BOARD OF VARIANCE PLANNING COMMENTS

BV #	6434	Address	878 MacDonald Avenue
X-Reference	BOV #21-00018	Hearing	2021 July 08

Project	New deck cover and previously constructed deck extension, deck stairs and carport to garage conversion to an existing single family dwelling.
Zoning	R5 Residential District
Neighbourhood	Willingdon Heights – Single and Two Family Neighbourhood

BOV Item (1)

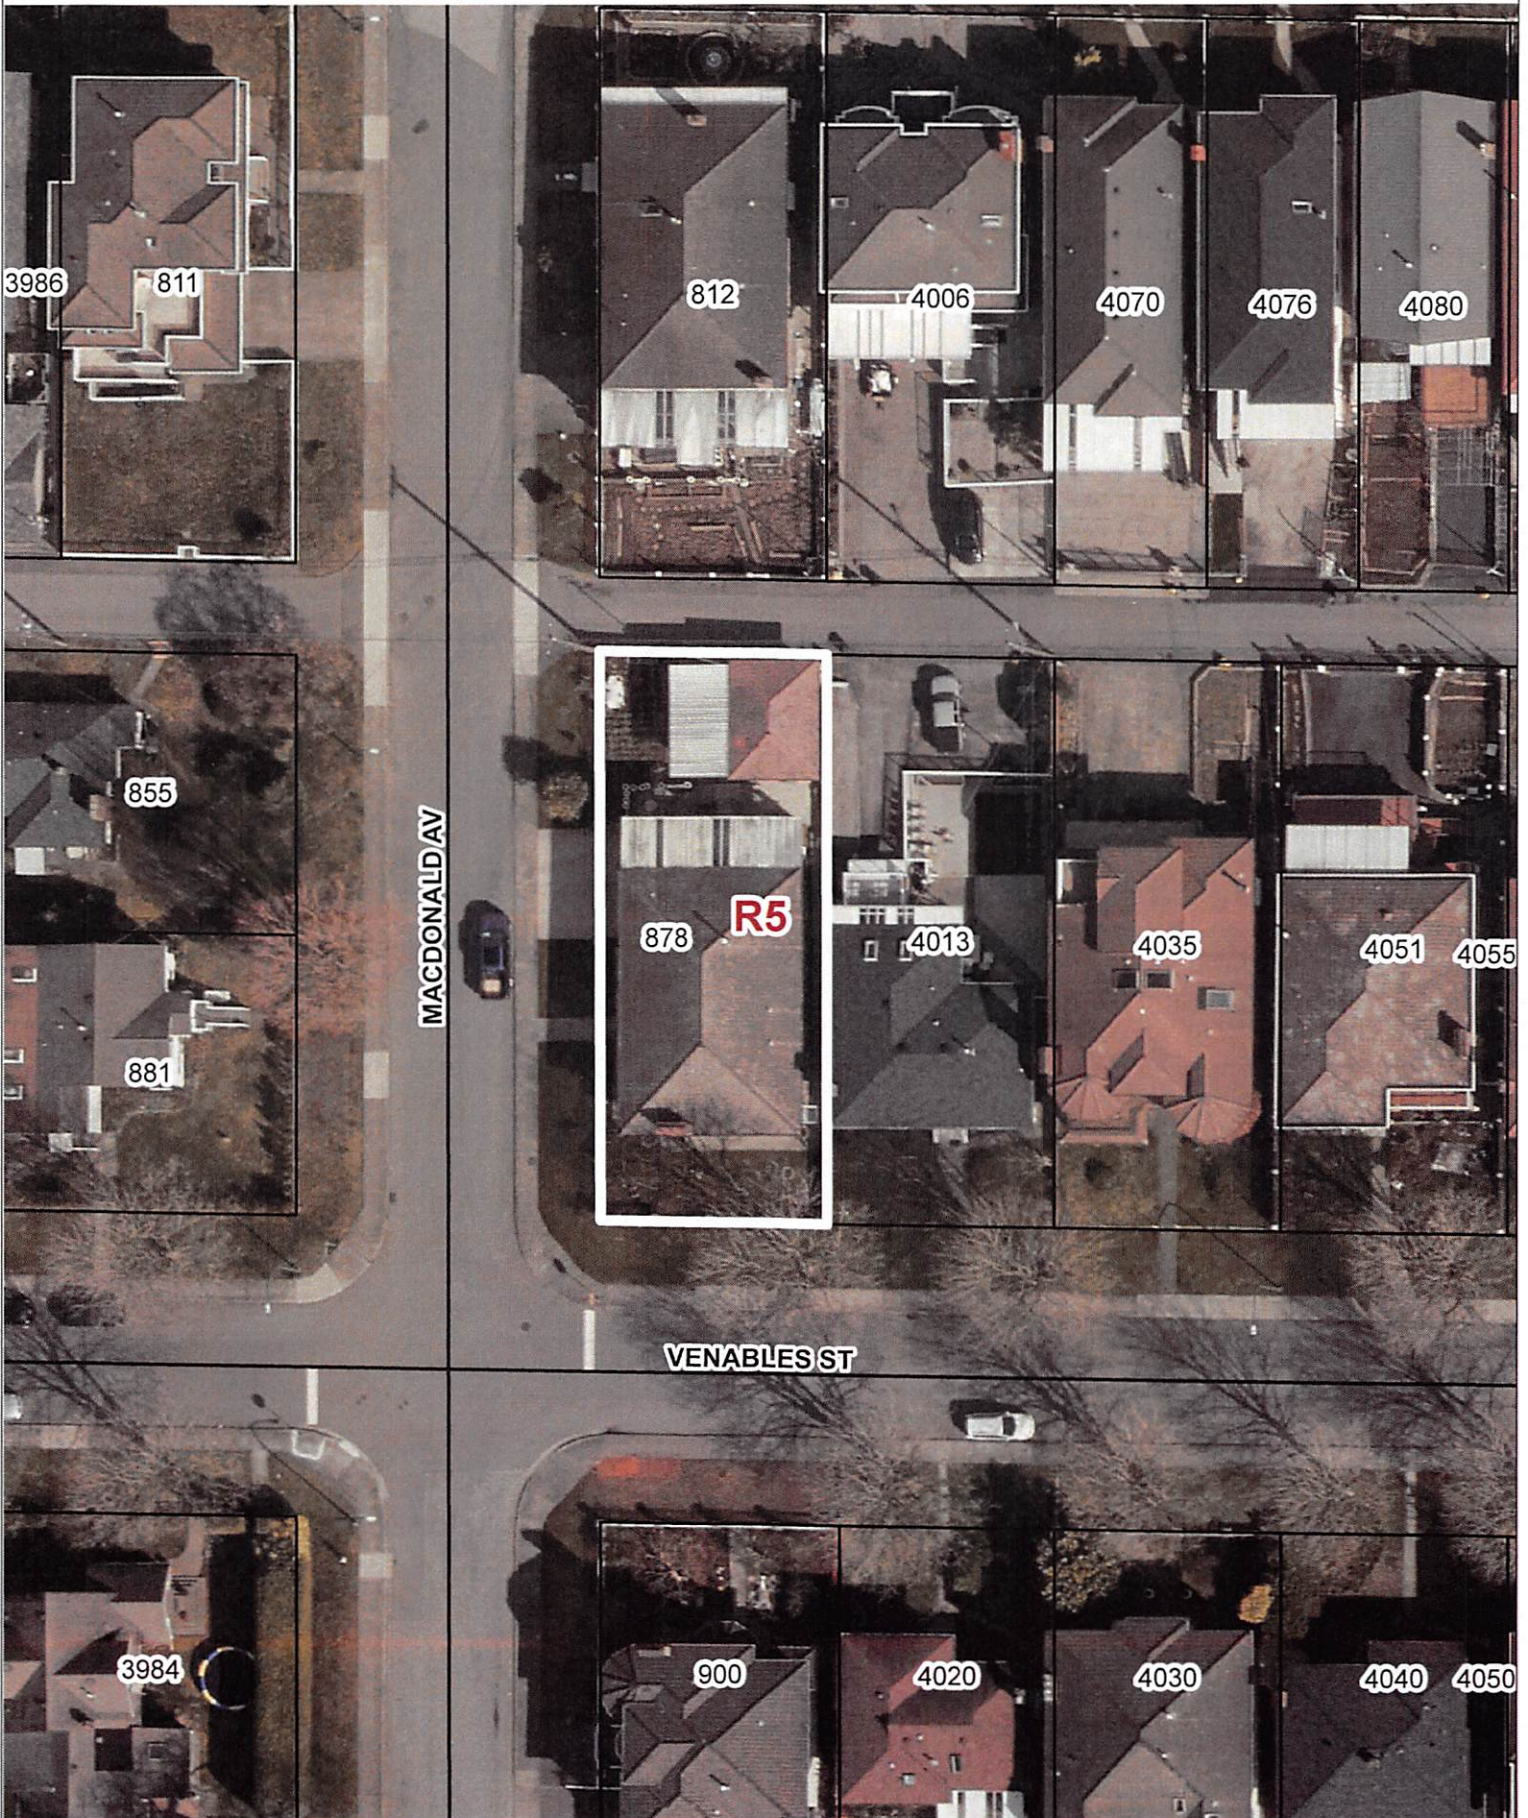
Appeal(s) to vary:	<p>1) Section 6.3.1 – “Distance between Buildings on the same Lot” of the Burnaby Zoning Bylaw requirement for the minimum distance from 4.50 m (14.80 ft.) to 4.12 m (13.50 ft.)</p> <p>2) Section 105.8(1) – “Depth of Principal Building” of the Burnaby Zoning Bylaw requirement for the maximum building depth from 18.30 m (60.00 ft.) to 19.64 m (65.50 ft.).</p>
Zoning Bylaw intent:	<p>1) A minimum separation between buildings is to ensure that overall massing of the buildings does not have a negative impact on the subject property and neighbouring properties, as well as to provide for sufficient outdoor space.</p> <p>2) Limiting building depth prevents the construction of long, imposing building walls that impact neighbouring properties.</p>
Variance Description:	<p>The proposed new roof cover over the existing deck at the rear of the dwelling and the enclosure of the existing carport below are the subjects of both appeals.</p> <p>The existing metal cover over the deck (which is not authorized) is proposed to be replaced by a new roof which would be a continuation of the existing main roof over the main body of the building.</p> <p>Also, the covered deck and the existing enclosed carport below are proposed to be slightly expanded by the area where the original stair existed at the</p>

- 1) This proposal does not decrease the distances between the principal building and accessory building (which remains reduced by 0.38 m (1.3 ft.) from the minimum distance required). Further, since the footprint of the enclosed carport is essentially the same (with the exception to the “filled in” north-east corner where the original stair was located), the existing green area remains unchanged.
- 2) Due to the carport enclosure and the roof cover above the deck, the principal building depth is measured from the front (south) façade of the building to the north (rear) face of the enclosed carport, and therefore, is increased by 1.20 m (3.94 ft.) from the original building length measurement. Considering the open deck form, this relatively small excess building length will not create a long imposing wall on the neighbouring properties.

BOV Item (2)

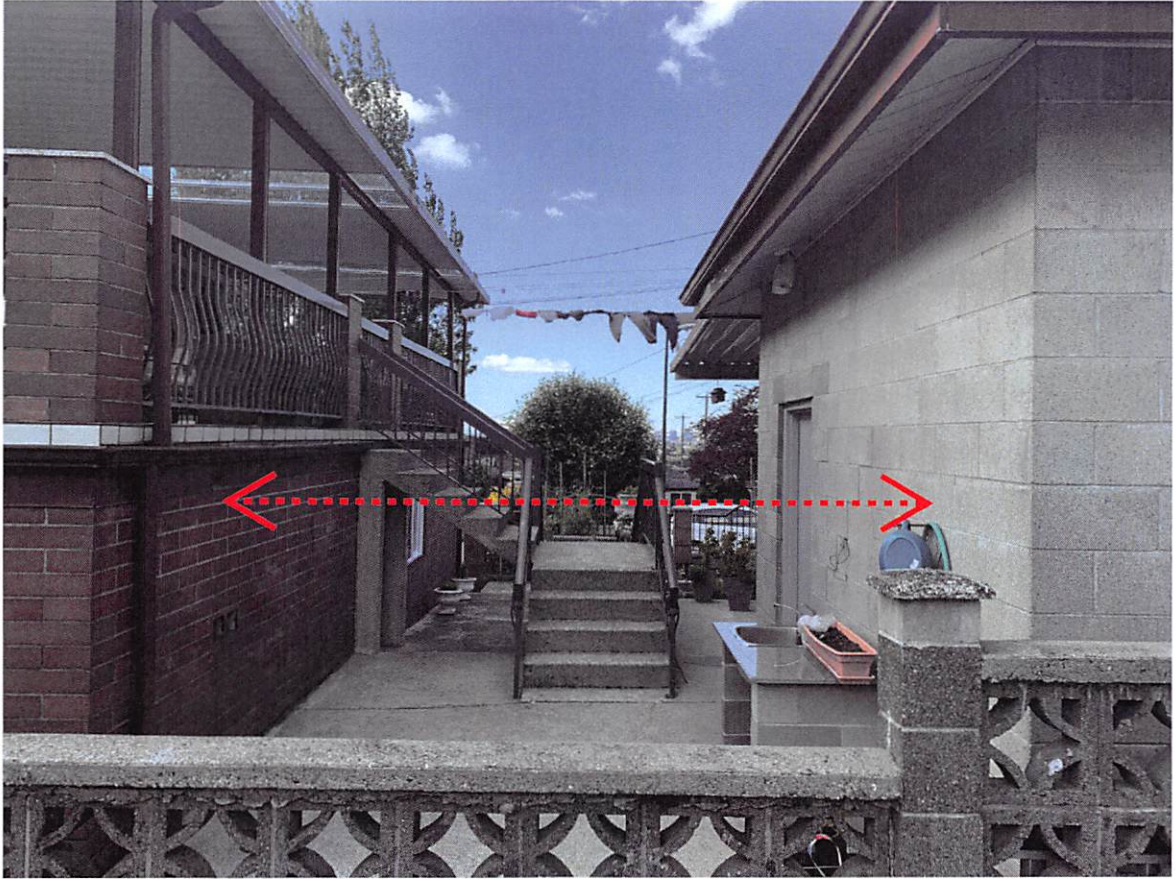
<p>north-east corner. The new stair, which projects at the center of the deck, does not contribute to the building depth or distance between buildings, as permitted by the Zoning Bylaw.</p> <p>1) The north-east portion of the covered deck and the enclosed carport below, overlap with the accessory building by a width of 3.35 m (11.00 ft.), resulting in the distance between two buildings reduced by 0.39 m (1.30 ft.). This overlapping area is the subject of this appeal. (see <i>attachment</i>)</p> <p>2) The covered deck and the enclosed carport below, exceed the permitted building depth by 1.07 m (3.50 ft.) over its entire width of 10.21 m (33.50 ft.). This outermost covered deck/enclosed carport area is the subject of this appeal. (see <i>attachment</i>)</p>
Subject Site Considerations	
<ul style="list-style-type: none">○ The subject property is a rectangular corner lot, 15.09 m (49.50 ft.) wide and 37.80 m (124.01 ft.) deep, which is essentially flat.○ The subject property fronts Venables Street to south and flanks MacDonald Avenue to the west. A vehicular access is provided from the rear lane to the north.○ The site is improved with a single family dwelling, including attached garage and attached carport, and an accessory building, originally built in late 1970 s.○ The existing dwelling observes a depth of approximately 16.30 m (53.50 ft.), as measured from the front (south) facade to the rear (north) façade. The original rear deck projects further by 3.65 m (12.00 ft.). If the allowable 1.20 m (3.94 ft.) deck exclusion is considered, the original overall building depth is 18.75 m (61.56 ft.). Therefore, the existing dwelling and original deck is legal non-conforming with respect to the principal building depth.○ The distance between the original deck and the existing accessory building is 4.12 m (13.50 ft.), which is also legal non-conforming with respect to the distance between buildings.
